Proposed District Plan Change 72

Residential Area Review

OFFICERS REPORT FOR:

District Plan Change No. 72 – Residential Review

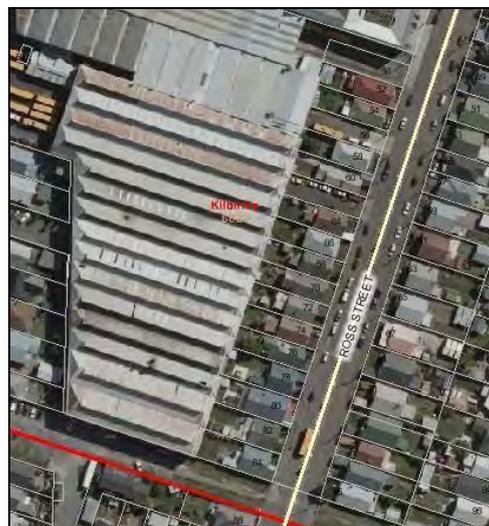
- Include the properties between 52 and 84 Ross Street within the Kilbirnie Area of Change shown on planning map 6. (**submission 44**)
- Exclude Kilbirnie Crescent from the Kilbirnie Area of Change. (**submission 81**)

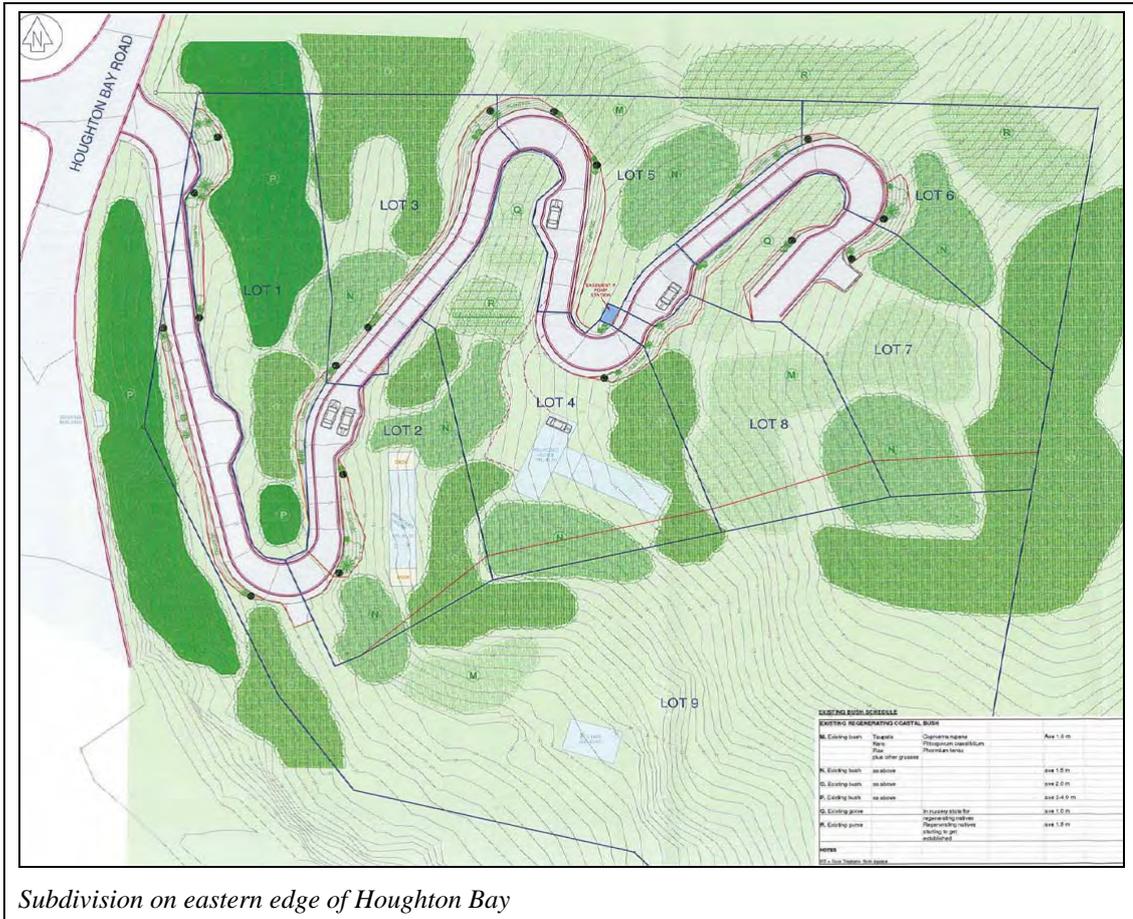
Submission 53 relates to a large property located on the eastern side of Houghton Bay. The submission requests that the property be removed from the RCE because it does not fit the basic criteria for inclusion in the area. In particular:

- The majority of property is located above the 13 metre contour so it is not possible to comply with the District Plan standard
- The property is largely undeveloped and does not demonstrate the development typology described in policy 4.2.2.2 of a strip of buildings running along the base of the escarpment
- There is no escarpment in this location, rather a headland with cuttings developed as part of the formation of The Esplanade/Queens Drive

Officers acknowledge that the site in question does not display the development patterns typical of the RCE. It is unusually large, extends further inland than most other properties and is largely undeveloped.

Officers also agree that policy 4.2.2.2 current focuses on the predominant pattern of development in the RCE (i.e. a row of residential dwellings at the toe of the escarpment), and does not explicitly recognise those areas that form part of the coastal environment, but which do not display these patterns. This leaves a policy void in terms of how any future development should be considered. However Officers do not consider that this means that these areas should be excluded from the RCE.

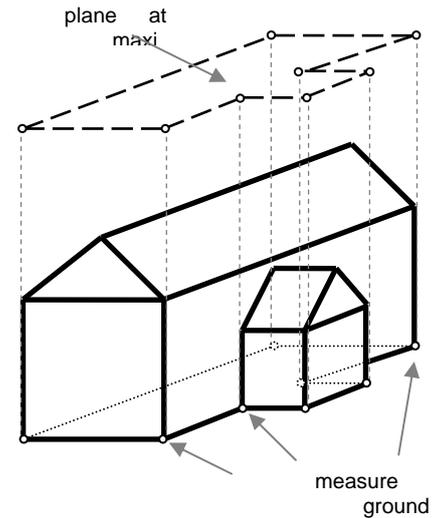
- Amend the definition of ground level to allow for the use of an assessed ground level where earthworks have been carried out on the boundary. (**submission 3**)

DPC 72 amended the definitions for ground level that are used to measure building height and to measure building recession planes. The definitions were amended on the basis that the existing definitions were overly complex and difficult for users of the plan to interpret.

The definition for measuring building height was amended by removing the tool used to measure 'assessed ground level'. The new definition reads as follows:
